BOSTON EDISON COMPANY
800 BOYLSTON STREET
BOSTON, MASSACHUSETTS 02199

BECO 85-134

License DPR-35
Docket 50-293

RESPONSE TO NRC ACTION ITEMS

F.W.P. No. F-251

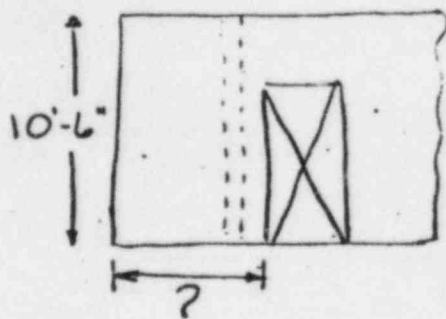
SK-452, WALL 188.10 S
indicates an overall
dimension of 40'-9" &
the dim. in question as
9'-3". Please clarify
these dimensions.

Response to F.I.R. 12 For Masonry Wall Plane SOUTHAnalysis Prob. No. 251 Wall I.D. No. 188.10 (SK-)F.W.P. No. F-251 is as follows:Prepared by Flanery Date 3/9/81Checked by Don't Date 3/9/81Sheet 1 of 1
